Addendum #2

Project: Rowan University – Science Hall 121 NMR Conversion

1 OVERALL FIRST FLOOR PLAN
A-102 SCALE: 3/32" = 1'-0"

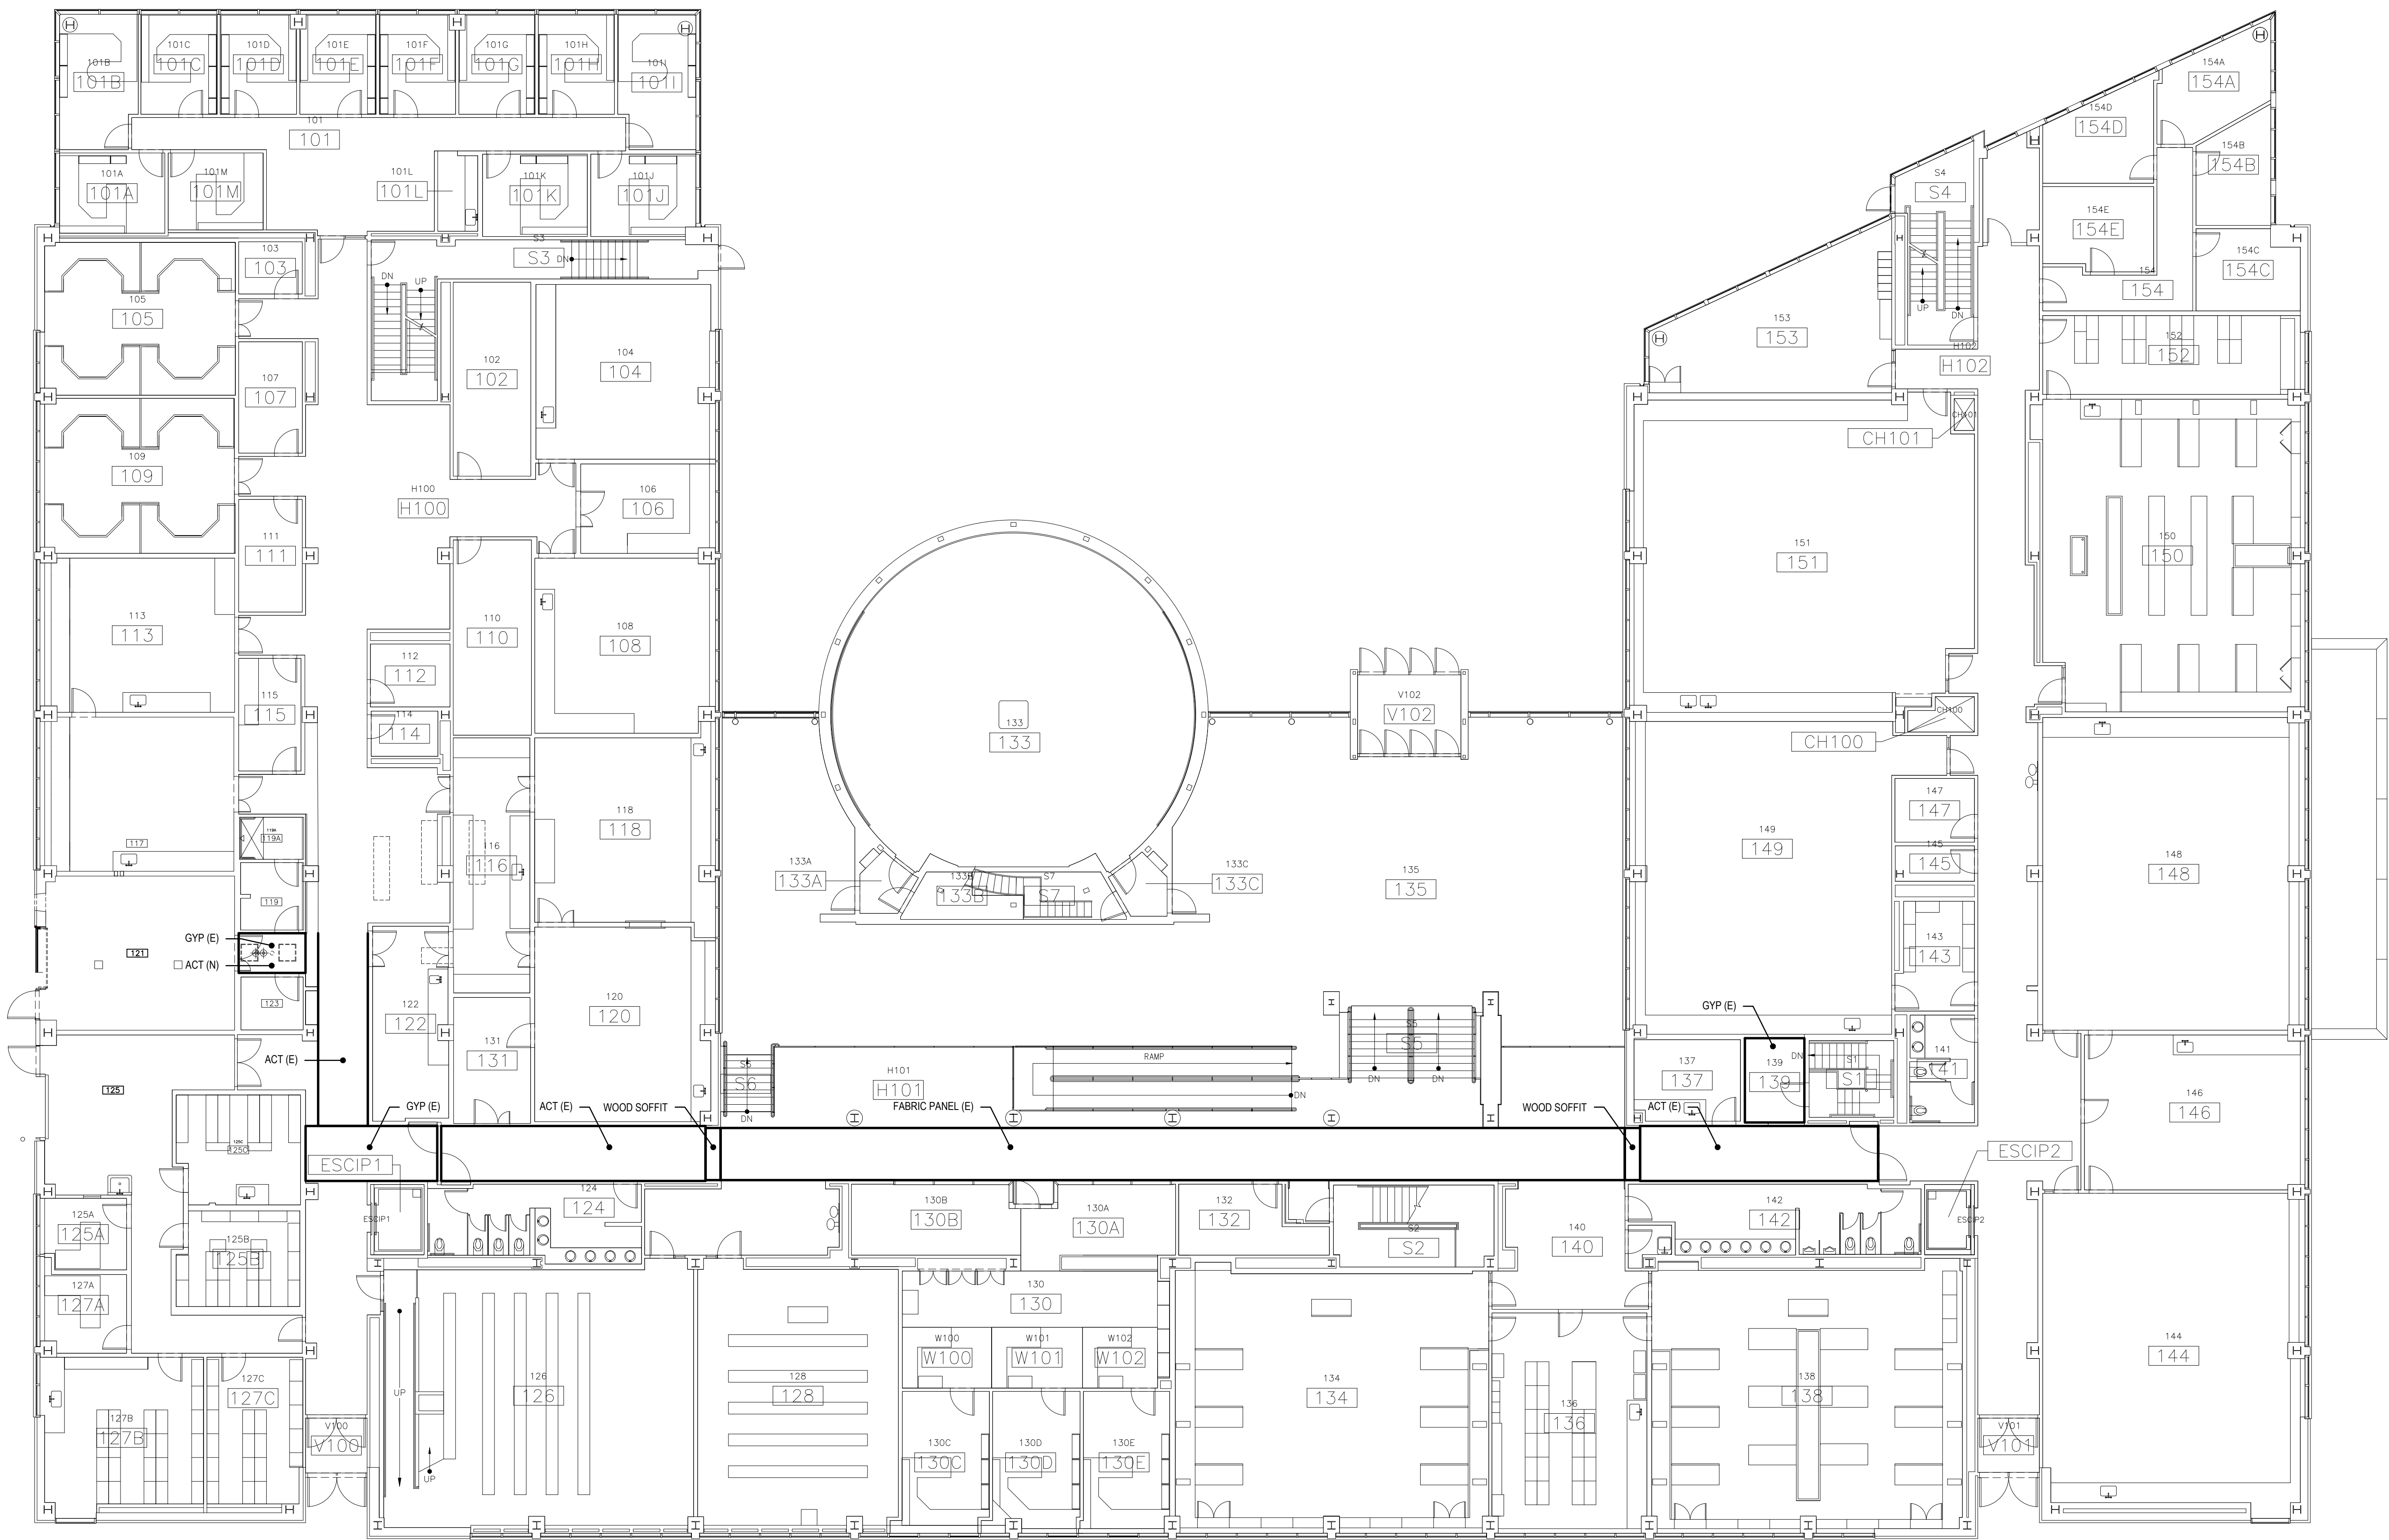
1. Added drawing A-102 – Architectural Overall Floor Plan
2. E-111 – Revised and clarified conduit routing location.
3. E-600 – Revised wire size

NOTE:
DEMOLISH AND REPLACE GYP CEILINGS TO FACILITATE CONDUIT
INSTALLATION. PAINT TO MATCH EXISTING CEILING.

ELECTRICAL CONTRACTOR RESPONSIBLE FOR REMOVING AND
REINSTALLING TILES IN ACT AND FABRIC PANEL CEILING AREAS.
COORDINATE WITH ELECTRICAL CONTRACTOR.
